SS. PETRAKIS NOMIKOS

REINFORCEMENT REQUIRED ON ACCOUNT OF REMOVAL
OF 2ND AND 3RD DECK

Additional stiffening required
for removal of 2nd & 3rd decks
on holds

PLAN AT 2ND D^K
STRENGTH 48" BROAD

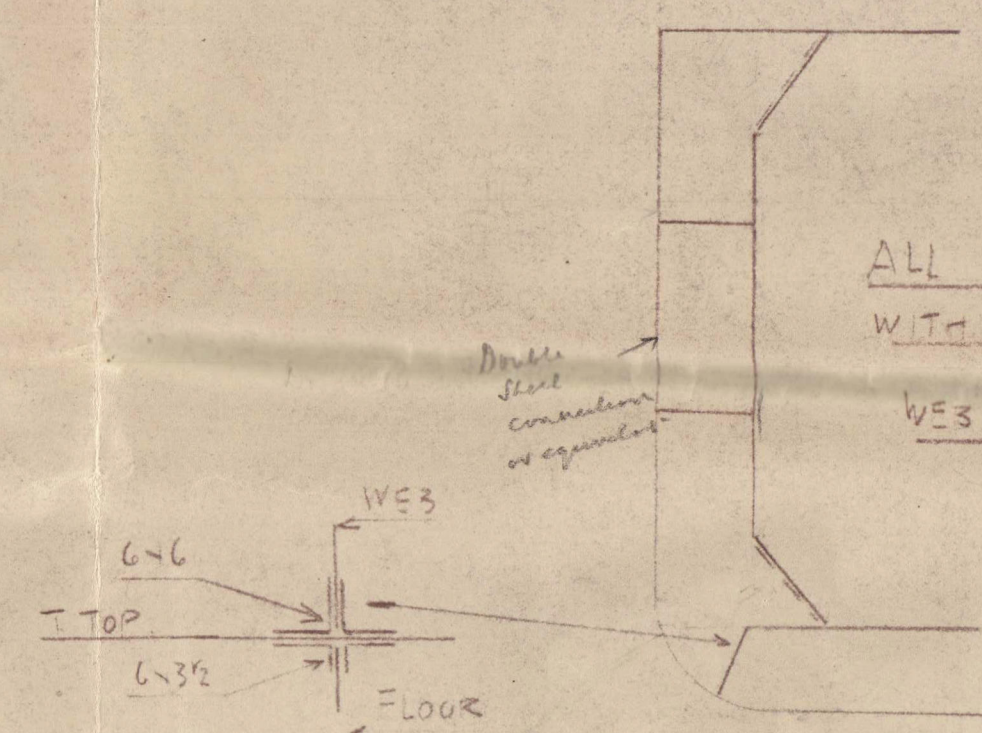
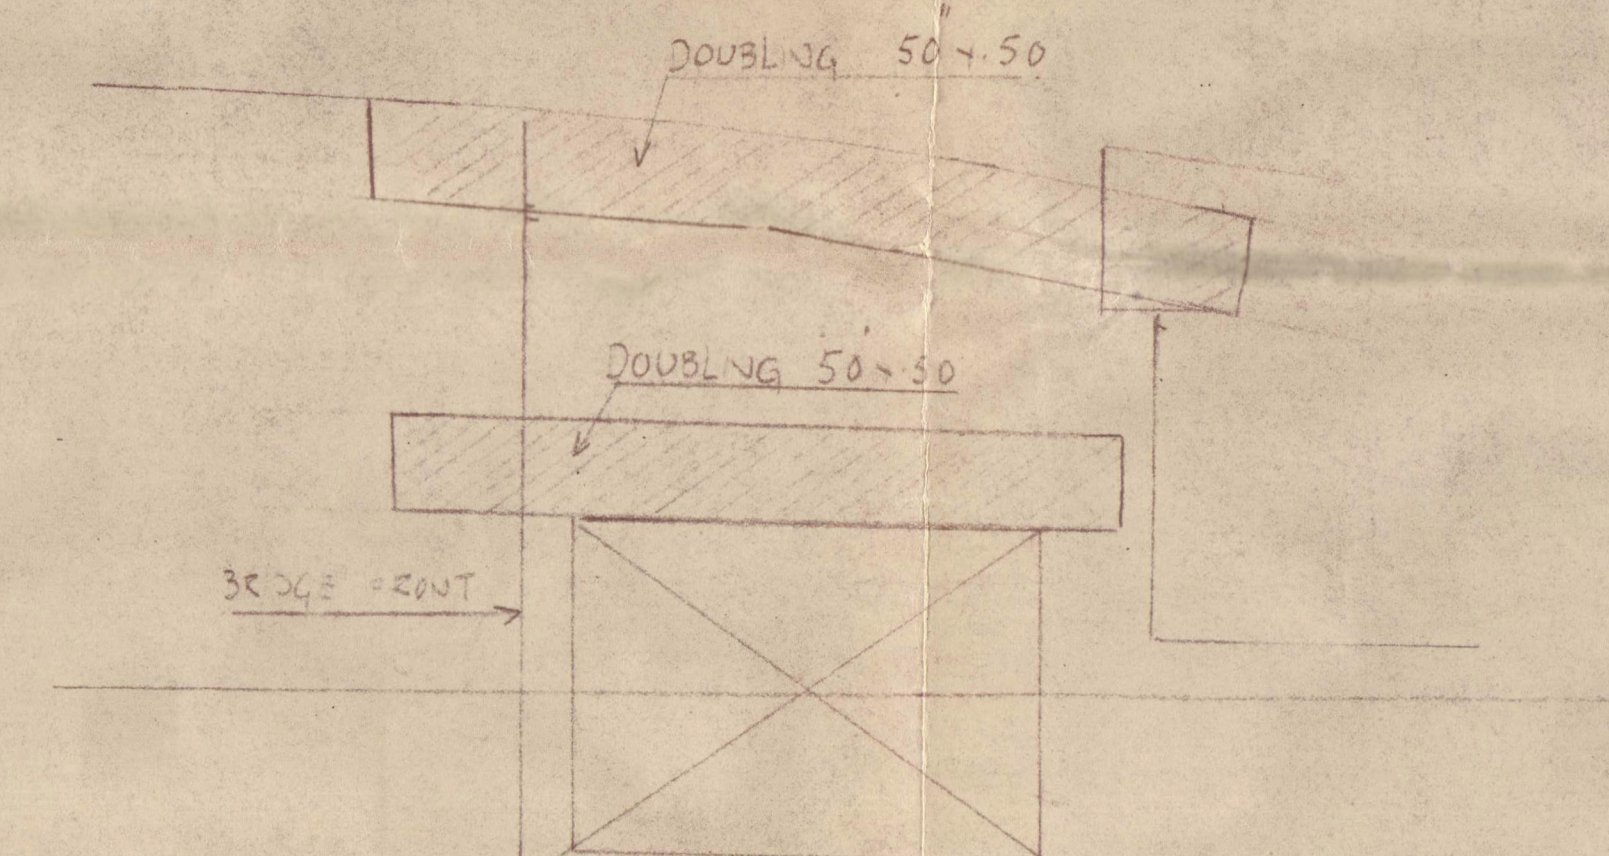
PILLARS TO BE FITTED TO
U D^N IN ACCORDANCE
WITH RULES TALKING

ALL WEBS 48" x 46
WITH FACE ANGLES AS SHOWN ON PROFILE
WEBS TO BE CONTINUOUS
